**WHEELING PLAN COMMISSION
THURSDAY, JULY 27, 2017 6:30 P.M.**

REQUEST FOR PLAN COMMISSION ACTION
STAFF PROJECT REVIEW

RE: **Docket No. PC 17-11**
Promise and Fulfillment Community Church
5110-6360 Capitol Drive
Minor Site Plan and Appearance Approval for Landscaping

RE: **Docket Nos. 2017-6AB & PC 17-12 & SCBA 17-19**
Wolf Crossing
411-415 N. Wolf Road
(2017-6A) Special Use-Site Plan Approval of a Preliminary
Planned Unit Development for Multi-Family
Residences
(2017-6B) Special Use-Site Plan Approval of a Final
Planned Unit Development for Multi-Family
Residences
(PC 17-12) Approval of a Final Plat of Subdivision
(SCBA 17-29) Appearance Approval of a Subdivision Sign

SITE DATA- PROPOSED PLAN

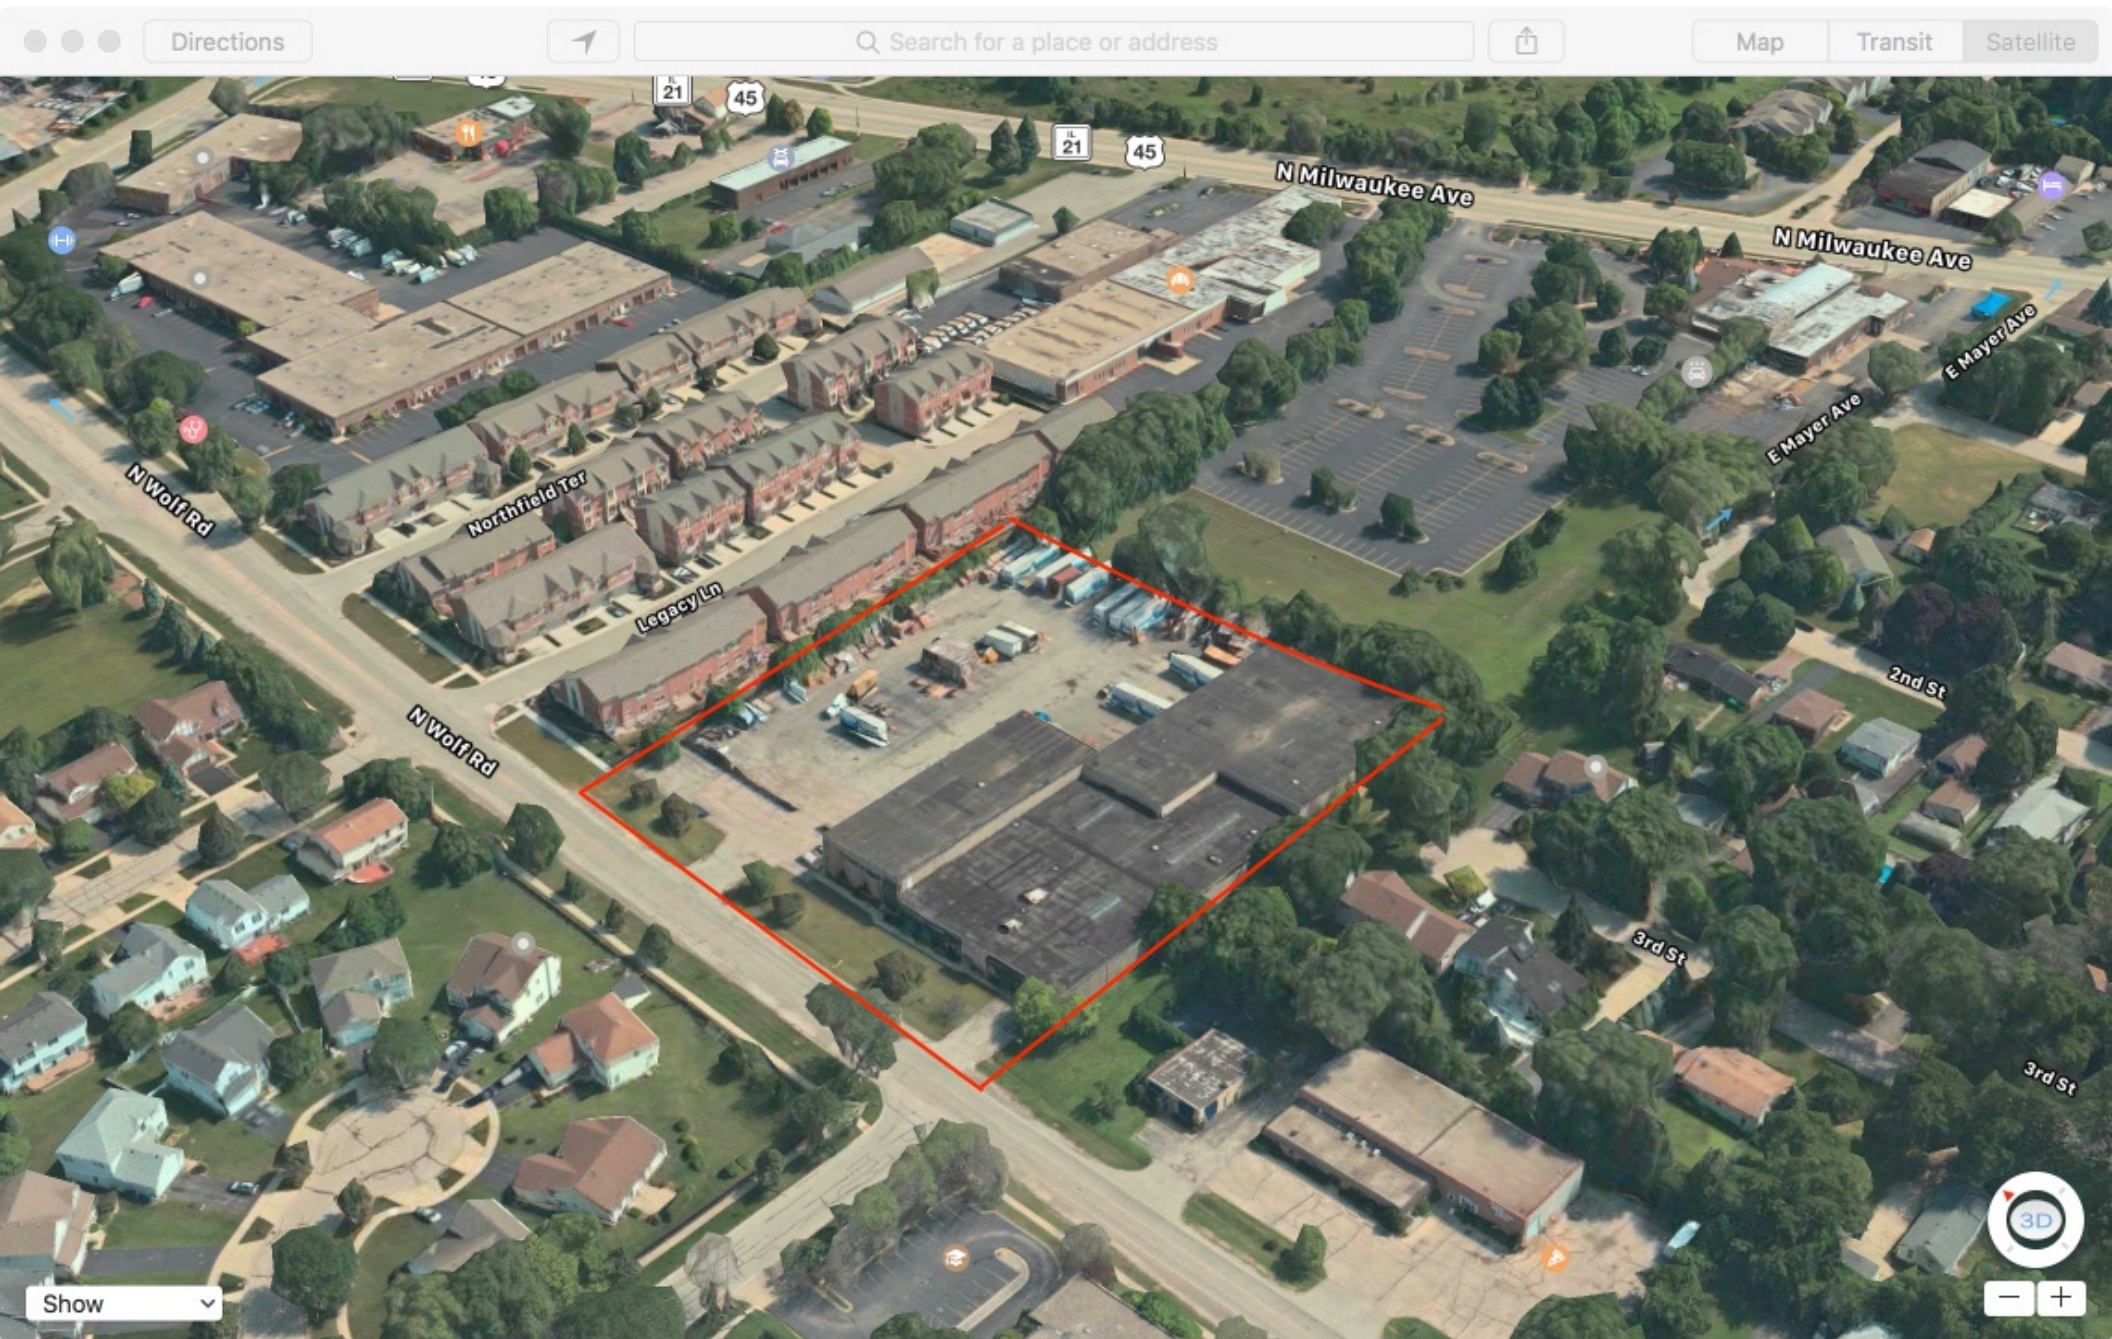
1. Building Setbacks: The applicant lists three setback variations in the project narrative, but the [Site Plan](#) shows differing dimensions for those variations. The required building setback for all yards is 30 feet. The written narrative requests a front/street side setback of 8.39 feet. However, the site plan indicates a minimum setback of 9'11.5" (which equates to a variation of 20'0.5"). The written narrative requests a rear setback of 15.31 feet. However, the site plan indicates a minimum setback of 16'7" (which equates to a variation of 13'5"). The written narrative requests a north interior side setback of 10 feet. However, the site plan indicates a minimum setback of 15'2" (which equates to a variation of 14'10").

Total Number of Parking Spaces: As the petitioner reports, the development provides for the required amount of parking per the Zoning Code: 4.0 parking stalls/ unit, plus 0.4 stalls/unit for guest parking. Each unit has two garage stalls and two parking pads outside the garage. Additionally, there are 16 guest spaces. The concern of staff is that the size of the garages. Based upon the [Lower Level Floor Plan](#) and the [photographs](#) of actual units provided, it appears that these garages will not function as two car garages. While two cars can be stored in these, the cars cannot be readily parked and accessed for normal use. The Plan Commission may wish to discuss if the size of the proposed garages are adequate to meet the parking demand of the development.

Additional features: As noted on the [Site Plan](#), 10' x 10' patios are provided in the rear of each unit. While the subdivision is nicely landscaped, it lacks other site amenities, such as a gathering space or a focal point.

NOTE:
THE TWO EXISTING HYDRANTS ADJACENT TO
THE PROJECT SITE, ALONG WOLF ROAD,
PROVIDE ADDITIONAL COVERAGE NOT SHOWN
ON THIS EXHIBIT

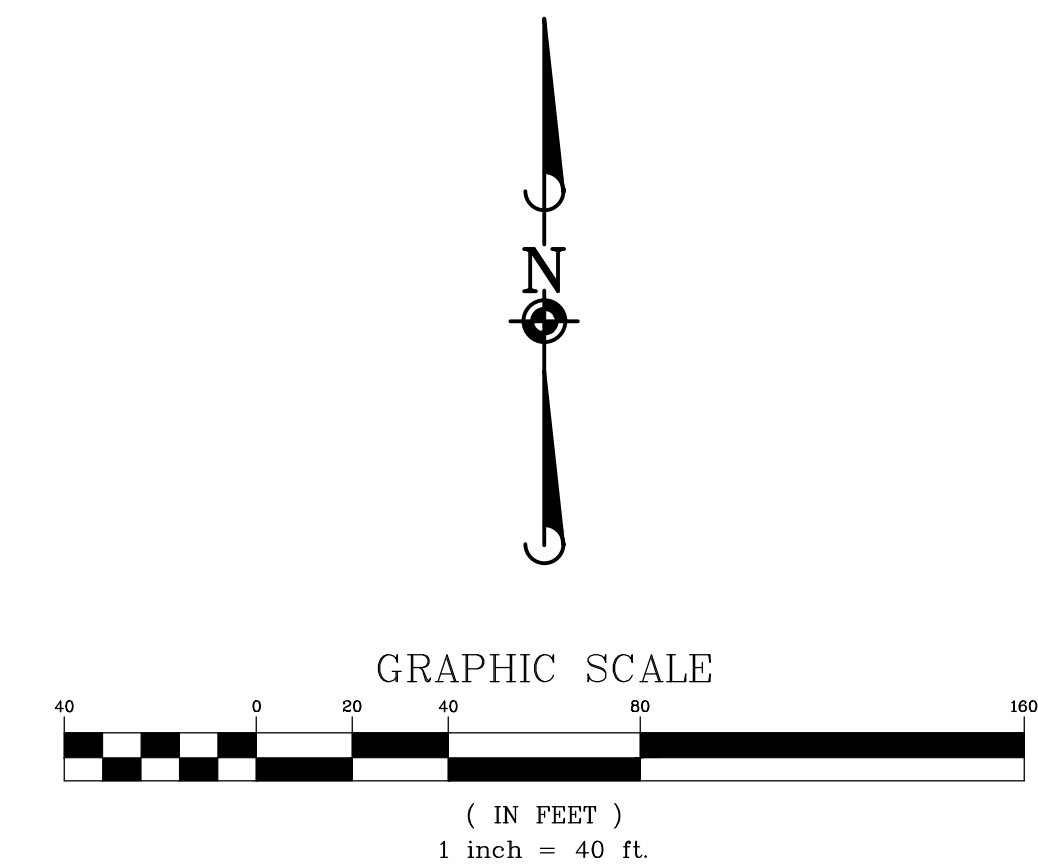
Fire Department Review: The Fire Department has submitted a comment memo on July 20, 2017. Most comments will be addressed at building permit. The Fire Department has some concern relating to the location of hydrants and the functionality of the snow removal plan. The Plan Commission may wish to ask the Fire Department about these concerns at the hearing.
